Staff Summary Report

SUBJECT: Hold a public hearing for a Planned Area Development Overlay and Development Plan Review for **AM/PM ARCO BROADWAY AND RURAL** located at 908 East Broadway Road.

DOCUMENT NAME: DRCr_BROADWAY_RURAL_AMPM_52207

DPR07057 – Development Plan Review including site plan, building elevations and landscape plan.

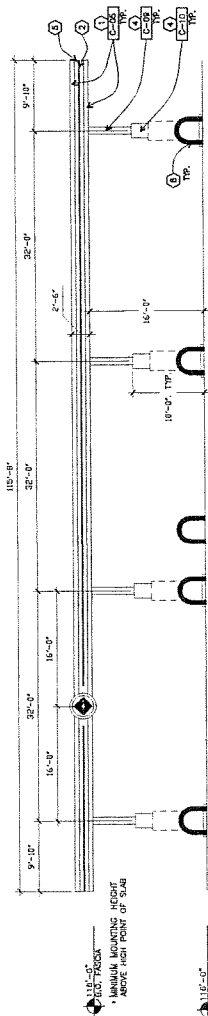
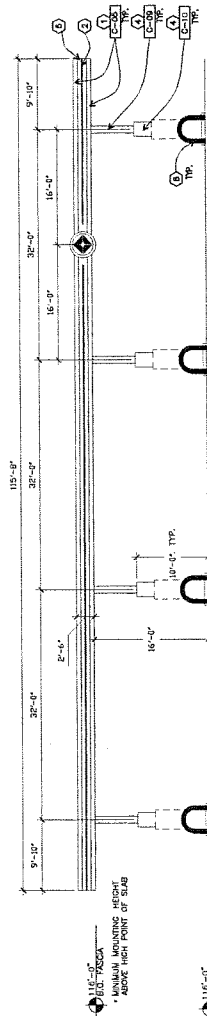
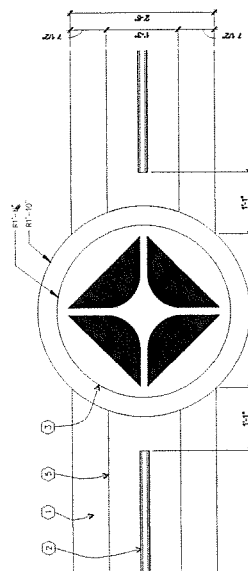
13. Provide main colors and materials with a light reflectance value of 75 percent or less. Specific colors and materials exhibited on the paint color sample board are approved by planning staff. Submit any additions or modifications for review during building plan check process. During completion of the development, planning inspection staff will field verify colors and materials.

14. Remove the marquee changeable poster boxes from elevation.
 15. Two signs are allowed on the fuel canopy fascia. Each sign may not exceed 6 s.f. and height of sign may not exceed 80 percent of the height of the canopy fascia and may not extend beyond top or bottom of canopy.

16. The color banding on the fuel canopy fascia and on the north elevation of the store is considered a building accent element and not part of the sign area. Do not internally or externally illuminate the color banding on the entry or fuel canopy.

17. Conceal roof drainage system within the interior of the store. Minimize visible, external features, such as overflows, and where needed design these to enhance the architecture of the store.

CN.4.1 – US – canopy (ARCO), canopy elevation

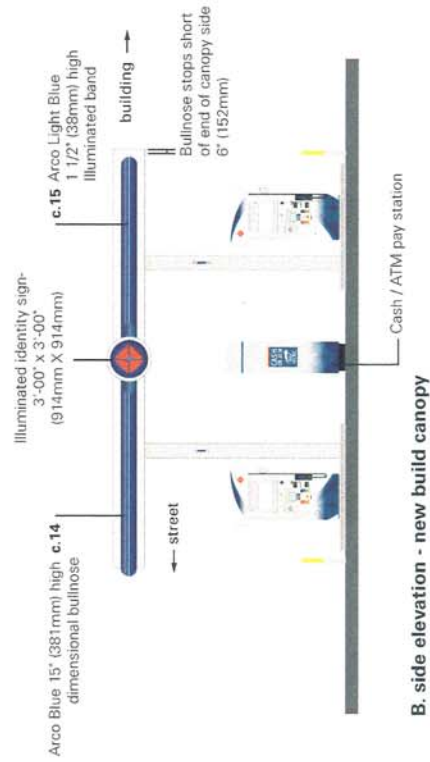
21. Fixtures for canopy lighting to be recessed.

- a. limit light on paving surface under canopy to maximum 40.0 foot-candles.
 - b. illuminate building entrance and exit side doors with minimum 5.0 foot-candles.
 - c. illuminate the electrical service entrance section room door pair with minimum 2.0 foot-candles.
 - d. illuminate the vendor parking with minimum 4.0 foot-candles, similar to a loading zone.
 - e. illuminate the public pay phone area with minimum 5.0 foot-candles.
- Follow requirements listed in the ZDC Part 4, Chapter 8 and in the guidelines listed in the ZDC under Appendix E "Photometric Plan."
